Access Compliance Report

Public Rights-of-Way

(Curb Ramps)

Intersection ID: 10181	Main Street: BACON_AV	Cross Street: ROSLYN_AV	Location: E
ADA ID: 0BB744597086	Ramp Type: PerpDiag	Initial Pass/Fail: Fail	Overall Compliance: No
		Severity Score: 35

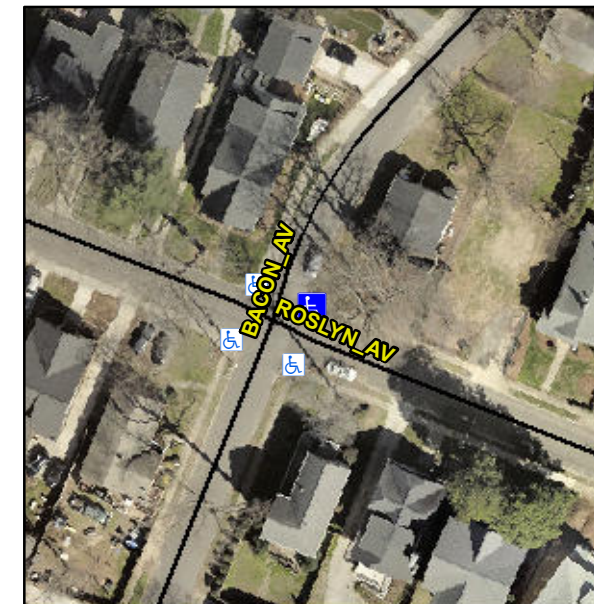
Not Found, R304.5.1

Compliance	Description	Data	Compliance	Description	Data
N/A	Ramp Length (in)	75.5	Yes	Ramp Slope (%)	6.8
No	Ramp Width (in)	30.0	Yes	Ramp XSlope (%)	0.7
N/A	Flare Type LT	N/A	N/A	Flare Type RT	N/A
N/A	Flare Slope LT (%)	N/A	N/A	Flare Slope RT (%)	N/A
N/A	Flare Traversable LT?	N/A	N/A	Flare Traversable RT?	N/A
N/A	Landing Length (in)	N/A	N/A	DWS Provided?	N/A
N/A	Landing Width (in)	N/A	N/A	DWS Contrast?	N/A
N/A	Landing Slope (%)	N/A	N/A	DWS Length (in)	N/A
N/A	Landing X Slope (%)	N/A	N/A	DWS Full Width?	N/A
N/A	Landing Curb? (Y/N)	N/A	N/A	DWS Offset (in)	N/A
N/A	Shared Landing?	N/A			
N/A	Gutter Ponding?	N/A	N/A	Gutter Slope (%)	N/A
N/A	Gutter Lip Ht (in)	N/A	N/A	Gutter X Slope (%)	N/A
N/A	Painted X Walk1?	No	N/A	Painted X Walk2?	No
	X Walk 1 Direction	To NW		X Walk 2 Direction	To SW
N/A	X Walk 1 Width (in)	N/A	N/A	X Walk 2 Width (in)	N/A
	X Walk 1 Slope (%)	1.9		X Walk 2 Slope (%)	0.7
	X Walk 1 X Slope (%)	0.9		X Walk 2 X Slope (%)	0.5

Remove & Replace Curb Ramp With Two New Directional Ramps or Equivalent.
